SUBJECT: Service Instruction M20-88A - STABILIZER TRIM STOP/SCREW MODIFICATION
Dated 12/14/2016.

SUBJECT: STABILIZER TRIM STOP/SCREW MODIFICATION

SERVICE INSTRUCTION M20-88A

Date: December 14, 2016

Figure SI M20-88-1

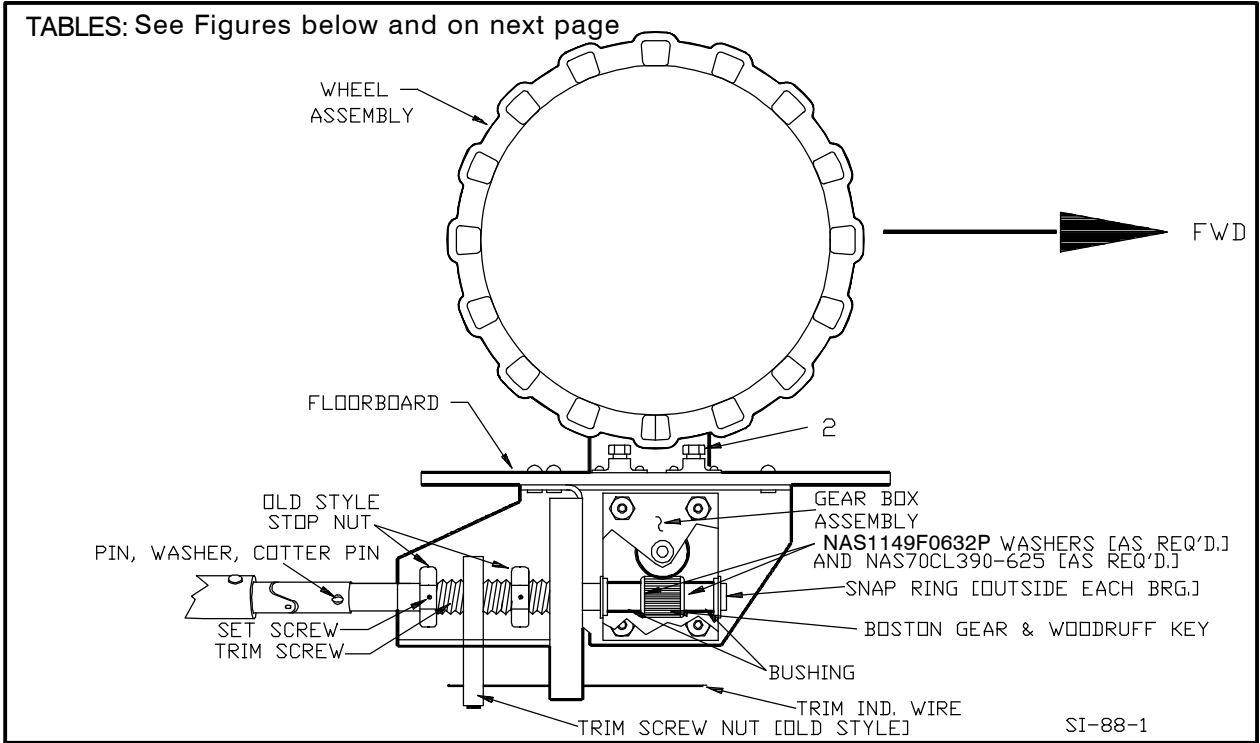
4. Remove cotter pin, washer and pin that secures trim tube universal joint to trim screw (Figure SI M20-88-1).
5. Loosen gear box bolts (Index 1, Figure SI M20-88-2) if not already done, and both NAS428-3-4 bolts (Index 2, Figure SI M20-88-2) to give slack in roller chain between upper and lower sprocket of trim control wheel assembly.

7. Remove roll pin, P/N RPA52-028-125-1125 holding lower sprocket, P/N 740049, to gear box shaft. Remove sprocket.
8. Loosen set screw, #6-32 x 1/8, in each existing trim stop so they will unscrew easily. Remove aft trim stop (DN stop) from trim screw (Fig. SI M20-88-1).

12. Measure and document longitudinal free play in trim screw shaft (end play) as assembled in the gear box assembly.
13. Remove forward snap ring from trim screw. Reference Figure SI M20-88-1
14. Lightly tap trim screw at forward end, with a plastic mallet, to drive trim screw, bushings, washers, gear and aft bearing from gear box assembly housing. Bearings are installed with loctite (Blue) at assembly, so some effort may be required to break it loose. **DO NOT DAMAGE BEARING OR HEATING THE HOUSING.**
15. When existing trim screw, and components attached to it, comes free from gear box housing, the bushings, washers, gears, woodruff key, snap ring and aft bearing will be removed. Retain components, except woodruff key, to place back on new trim screw (Fig. SI M20-88-1).

Figure SI M20-88-2

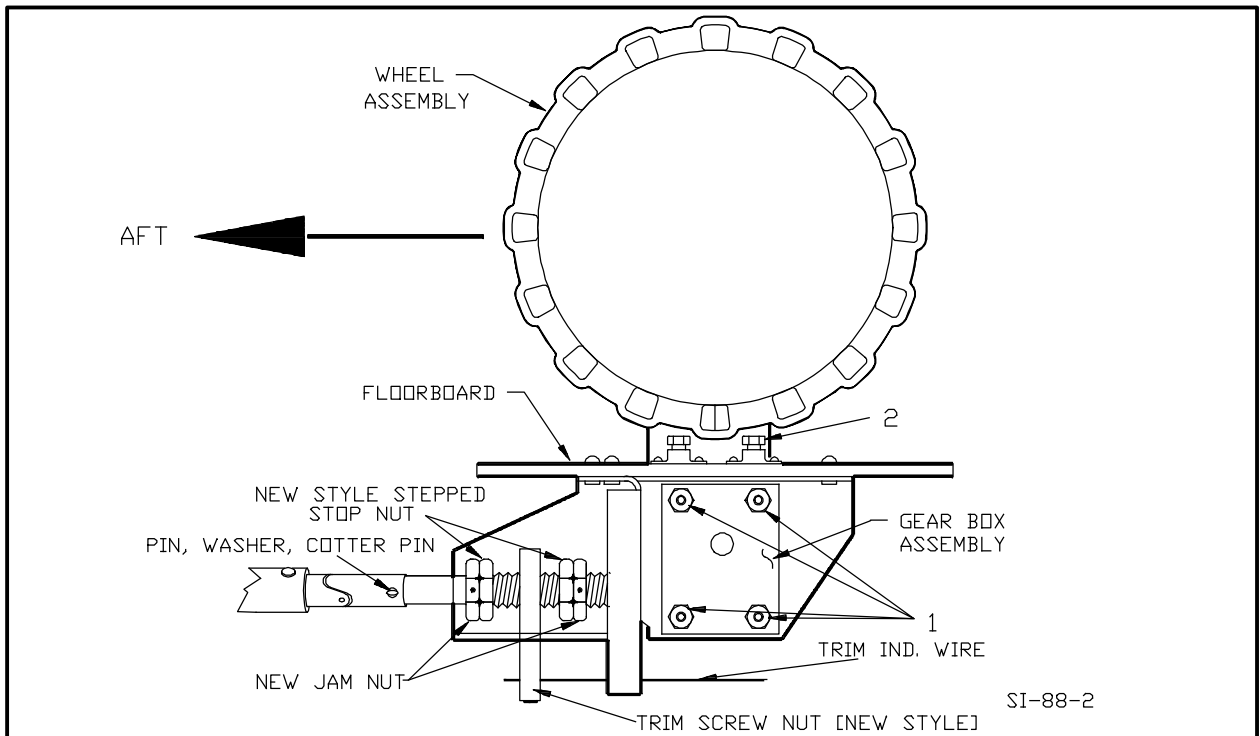
1. Remove belly access panels or smooth belly fairing to gain access to lower side of the trim control wheel assembly.
2. Remove trim indicator wire from trim screw nut by loosening set screw(s) that restrain trim wire.
3. Remove any brackets connected to gear box bolts (Index 1, Figure SI M20-88-2) both sides if required. Different models have different type of brackets.

22. Install one jam nut (UP stop side), P/N 740086-003 (M20J) or 740086-001 (M20K, M20L or M20M), on trim screw. Screw toward gear box housing leaving approximately 0.375 inch gap on threads between gear box and jam nut (Figure SI M20-88-2).
23. Install one stepped stop nut (UP stop), P/N 740086-007 (M20J) or 740086-005 (M20K, M20L or M20M) on trim screw. Screw toward gear box housing and against jam nut installed in step 22.

24. Position gear box/trim screw assembly to lower trim wheel assembly so new trim indicator nut, P/N 740086-011 (M20J) or 740086-009 (M20K, M20L or M20M) can be placed on trim screw and screwed in place to proper position within slotted bracket area. This is the reverse of Steps 9 & 10.
25. Install other stepped stop nut (DN stop) (stepped side toward trim indicator nut) on trim screw.
26. Install other jam nut on trim screw against stop nut (DN stop).
27. Reverse Steps 2 thru 7 to reposition gear box assembly back on trim wheel assembly. Do not tighten trim indicator wire set screw at this time. Position all other brackets but do not tighten bolts holding gear box assembly to trim wheel assembly (Fig. SI M20-88-2).
